RFI

RFI #: 2

Job: 17-011 17-011 B&B Theaters NLV7

Subject: Auditorium 1 Footing & Slab - Means & Method

FOOTING SKETCH

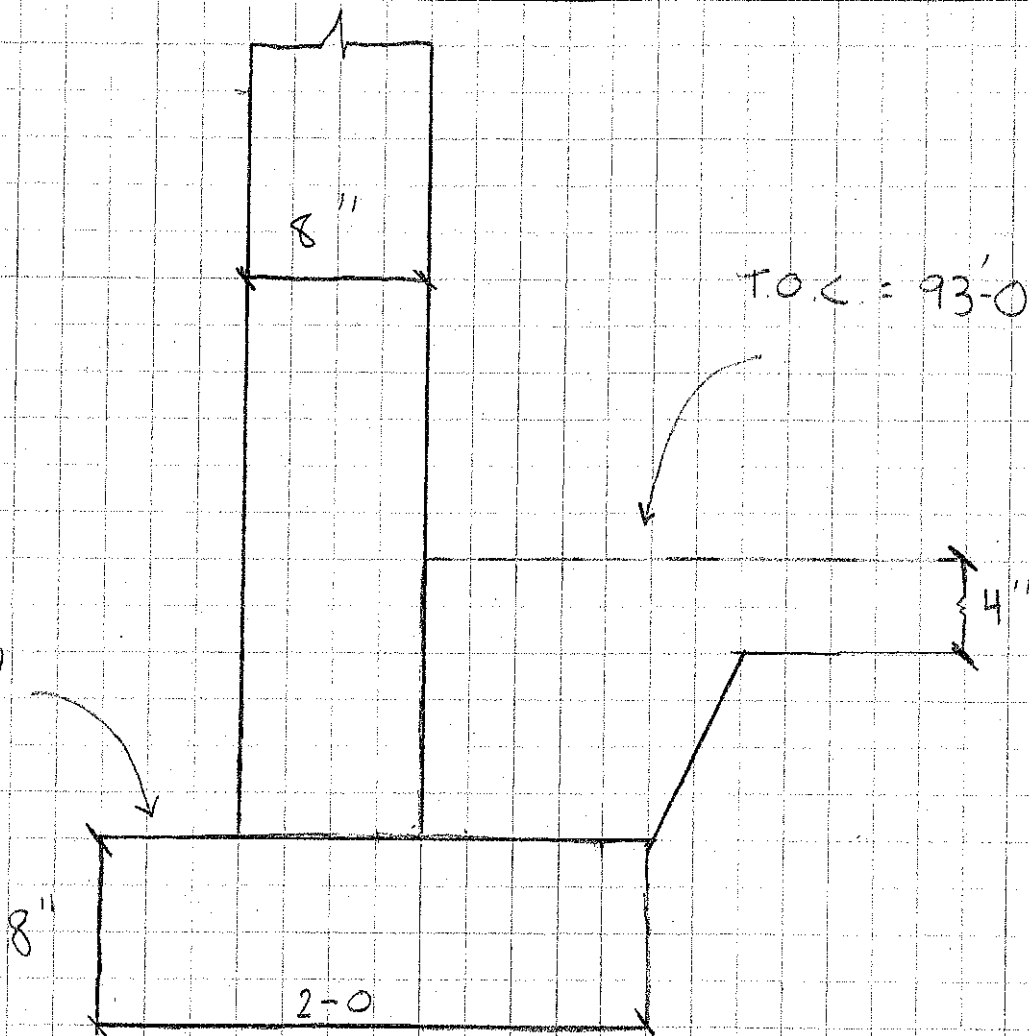
Summit concrete would like to continue the spread footing around the west and south sides of the lower auditorium 1 bowl, similar to the north and east sides per detail A1/S337. This would allow the CIP walls to be poured first on top of the footing. Then the lower 93'-0" slab poured last. See details.

This additional footing would be completed at no additional cost.

T.O.F. = 92'-0"

T.O.C. = 93'-0"

Detail between GRID 7-10 + GRID J-M

Approved to proceed so long as no additional costs.
